September 12, 2013

**Subject: Bingham Wind Project
Response to Additional Stormwater Review Comments
L-25973-24-A-N/L-25973-B-N, Bingham Wind Project, Bingham et al.**

We are pleased to provide the accompanying responses to Art McGlauffin's additional stormwater review comments dated August 28, 2013 for the proposed Bingham Wind Project. For ease of reference, we have repeated the comments below (*italics*) followed by our response (**bold**).

C GRASS LINED DITCH DETAIL
N.T.S.

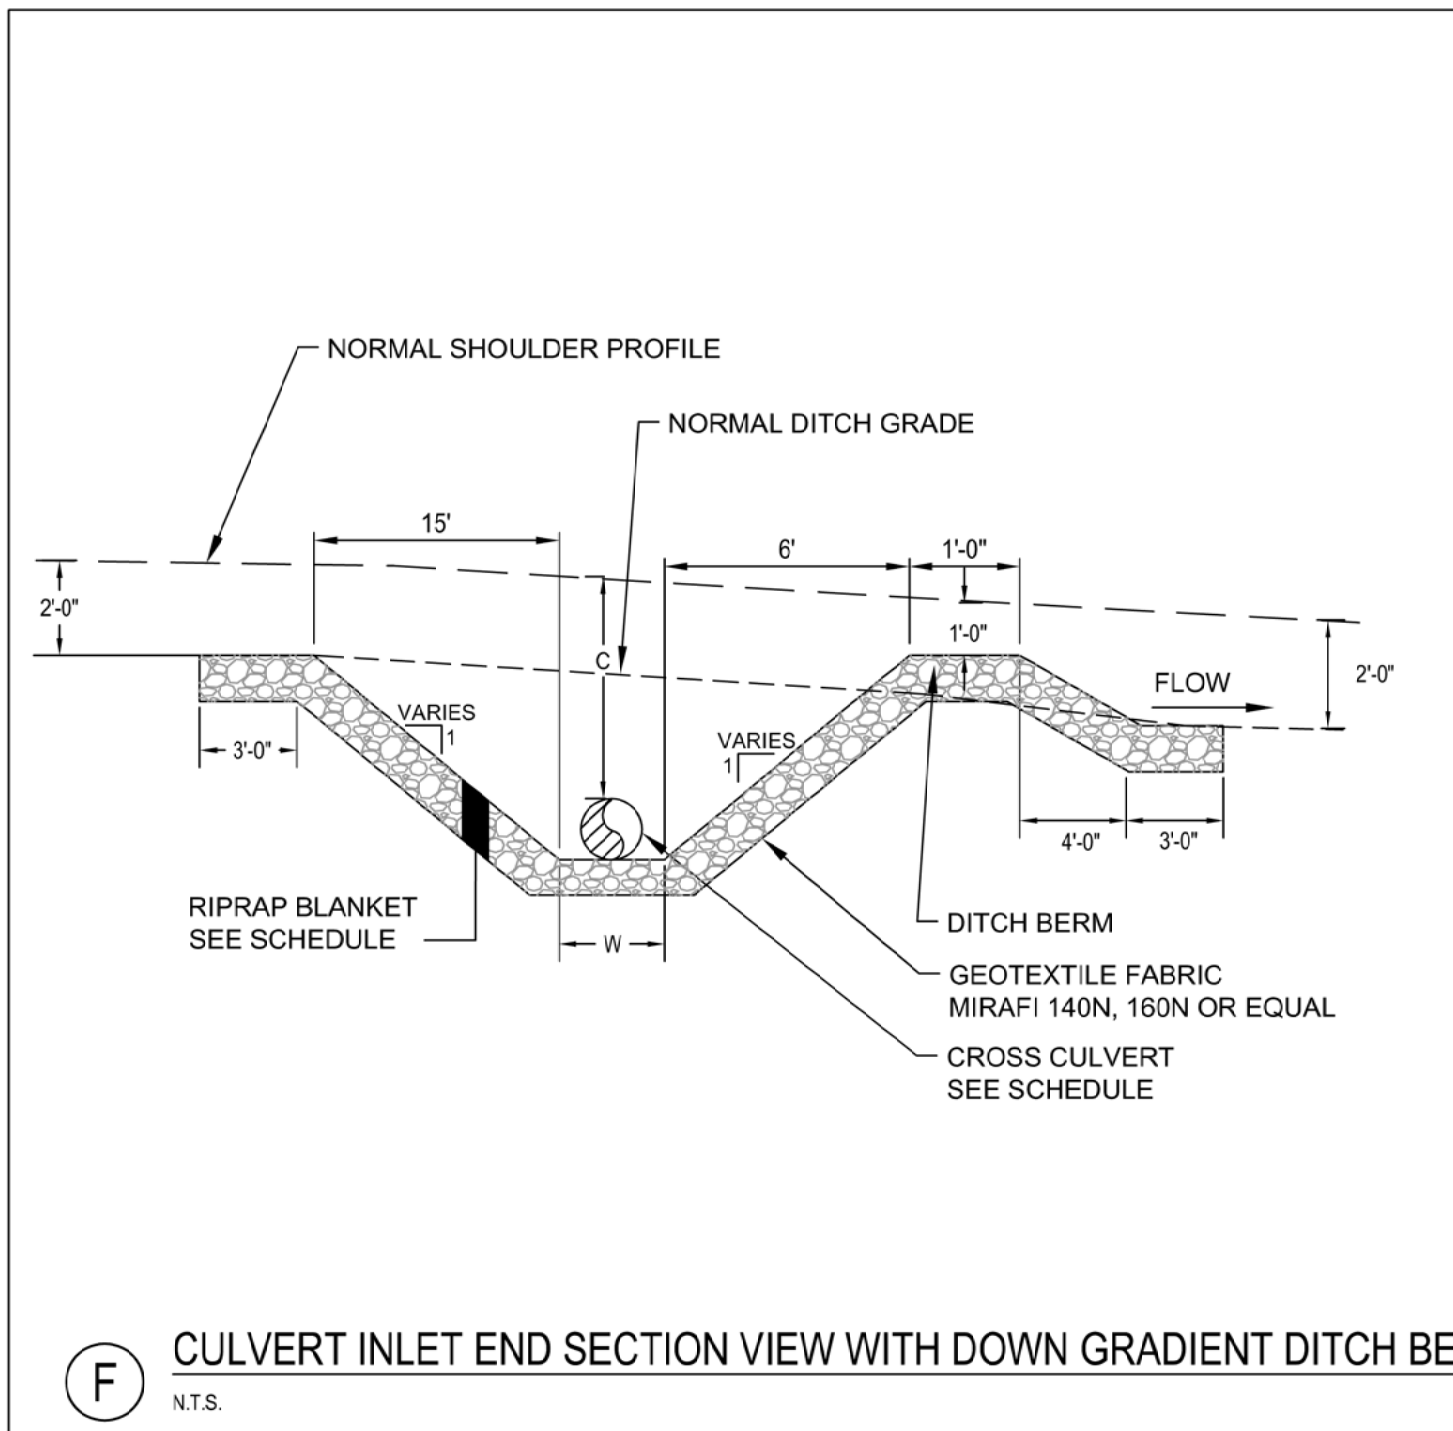
15. *Plan sheet C-7.0 – The applicant should revise the “Grassed Line Ditch Detail” to change note 6.B to require the erosion control mix used for ditch stabilization to be approved by the engineer and to change note 6.C to require the ditch to be protected by anchored mulch or erosion control matting.*

Note 6.A has been revised to include language specifying that erosion control mixes used shall be approved by the engineer of record.

Note 6.B has been revised to require approval of the erosion control blanket by the Engineer of Record.

Note 6.C has been revised.

See attached Sheet C-7.0.

C-9.1

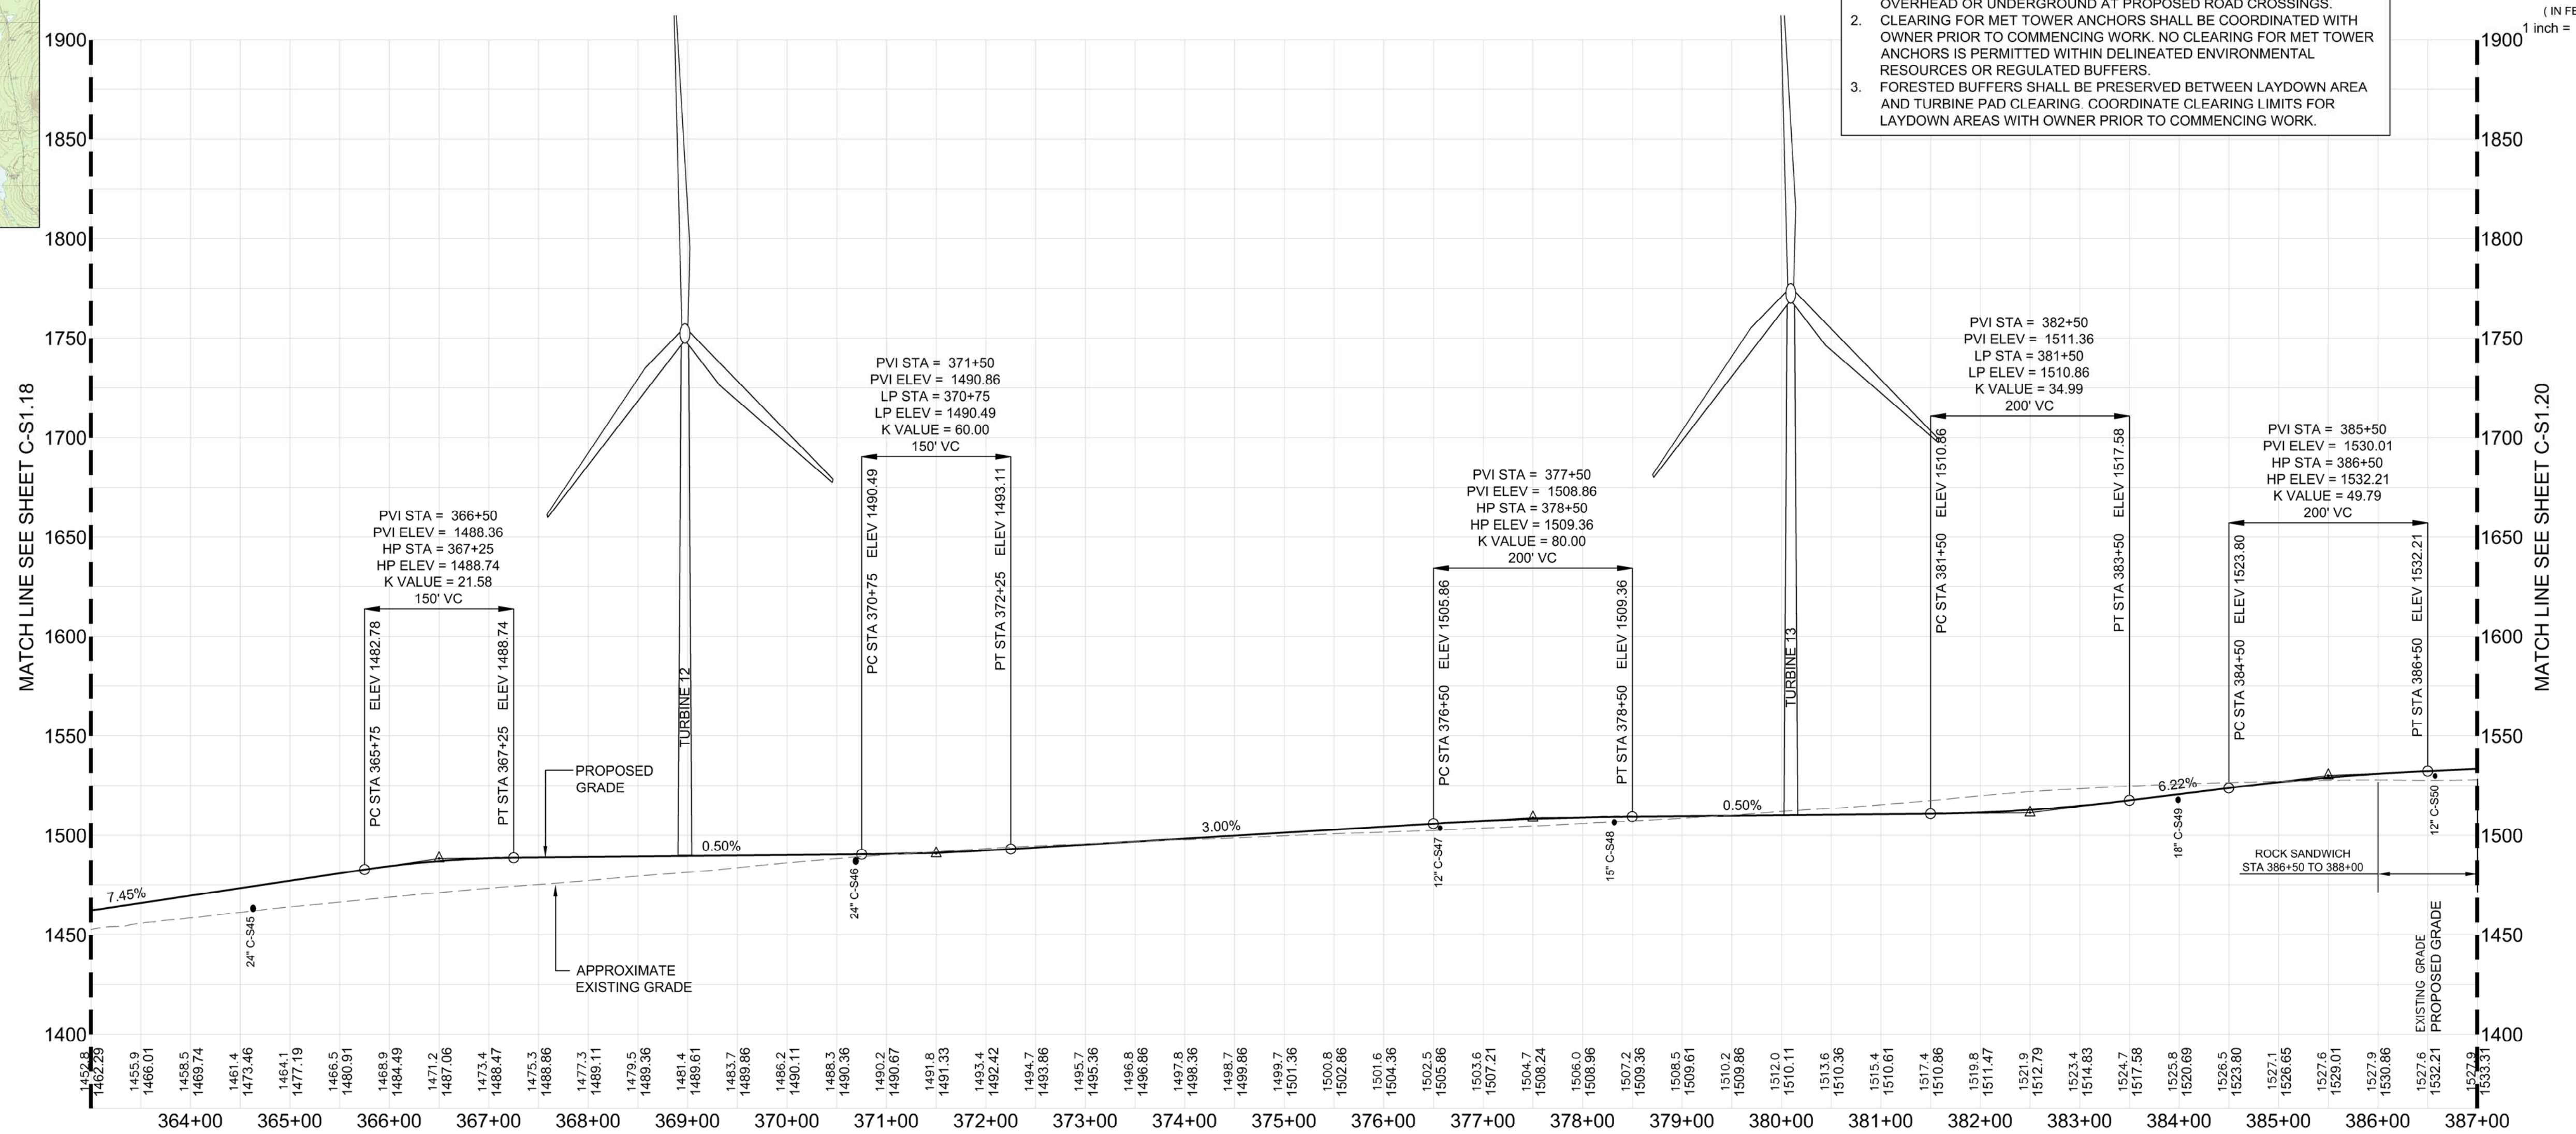
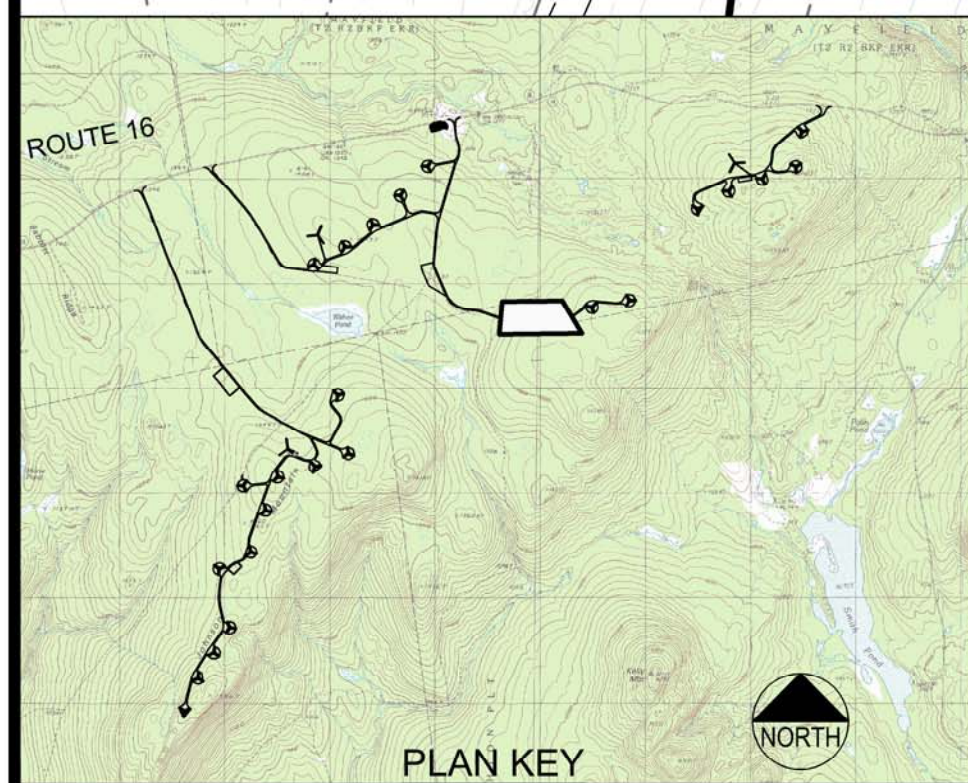
37. *The applicant should correct the treatment calculations for the Fall Brook watershed to eliminate roadside buffer AD-S11 treating runoff from South Crane Road 1 station 68+00 to station 71+50. This buffer is no longer on the project plans (see plan sheet C-S1.08).*

The treatment calculations have been revised. The total number of turbine pads requiring treatment in the General Standard Watersheds has been increased to a total of 37. Refer to attached Sheet C-9.1 and the Revised Treatment Calculations.

SHEET
C-S1.19

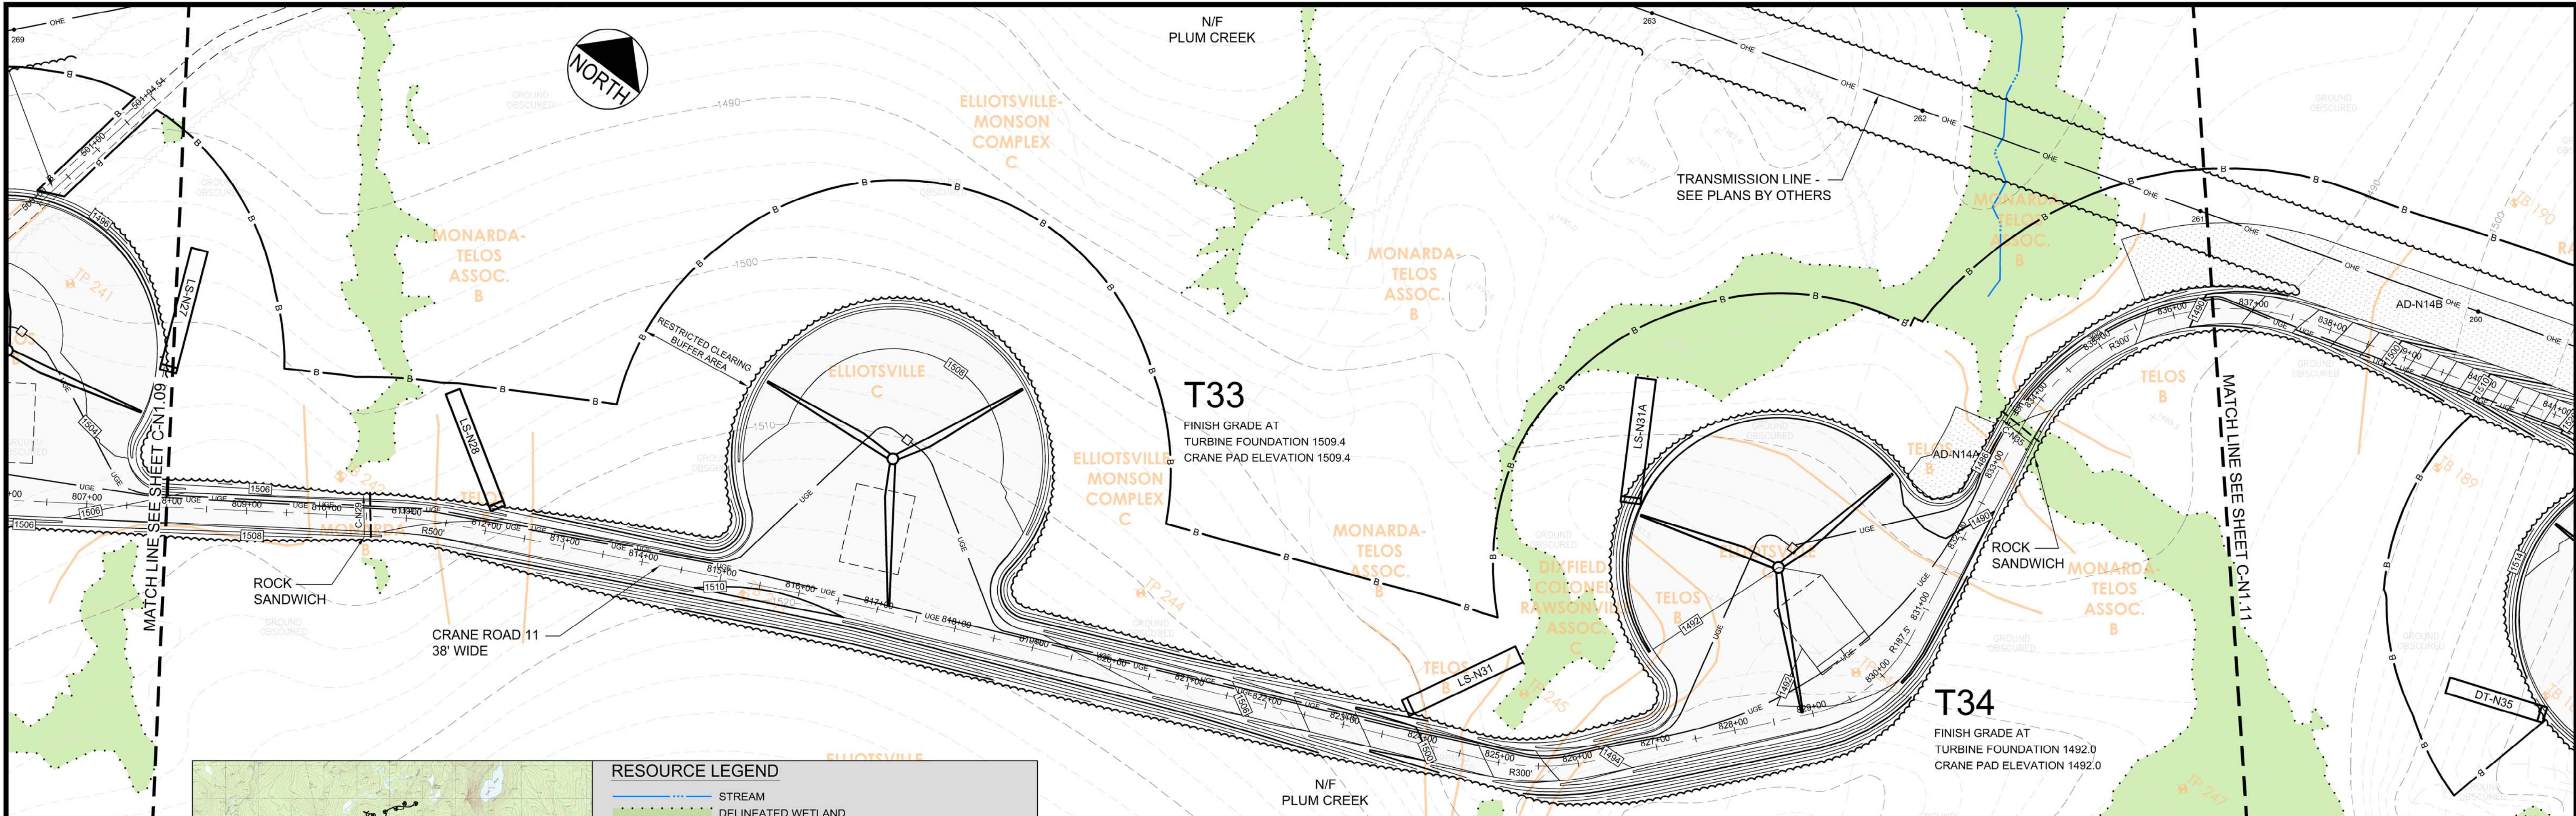
53. *The South Crane Road 5 ditch length draining to DT-S31 exceeds 190 feet (the maximum I am willing to allow for ditch turnout buffers with silt-loam soil). An additional turnout buffer will be needed along this road section or the buffer redesigned to be a buffer with stone berm level lip spreader (see plan sheet C-S1.19).*

DT-S31A has been added to provide an additional turnout buffer. See attached Sheet C-S1.19.
